Subject: Change of the air filter.

Affected: UL-Aircraft WT9 DYNAMIC
S/No.: All up to DY – 057/2004

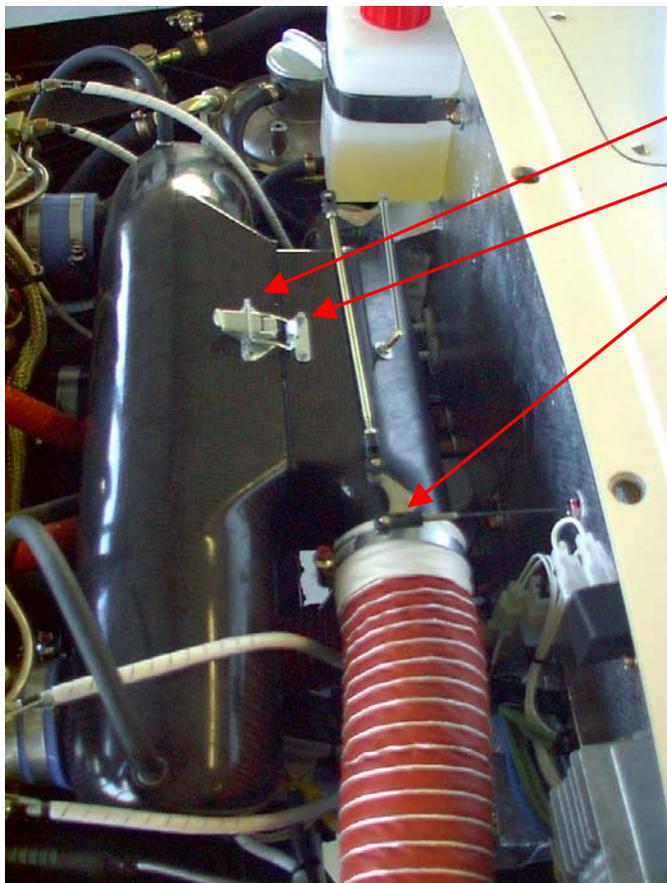
Reason: In the common operation of the UL – Aircraft WT 9 DYNAMIC has occurred short irregularities of the engine run. After regular carburetor check was there discovered a little dirt (flies and a little pieces of the grass) because the leakage and deformations of the air filter seat.

If you will discover the leakage or deformation on the air filter seat the type Purolator Typ A1794 is recommended to change the filter for the filter type Kingdragon AL 13 or filter type SF sprint filter P 102 Panel (D1 167 D2 89).

1. Demount the upper engine cowling
2. Remove the Airbox lock safety pin
3. Disconnect the Airbox preheating rod
4. Release the Airbox lock
5. Unclamp the part with filter
6. Replace the old air filter for the new one
7. Close and lock the Airbox, check the bottom lock connection
8. Secure the lock with safety pin
9. Reconnect the Airbox preheating rod
10. Mount the upper cowling back
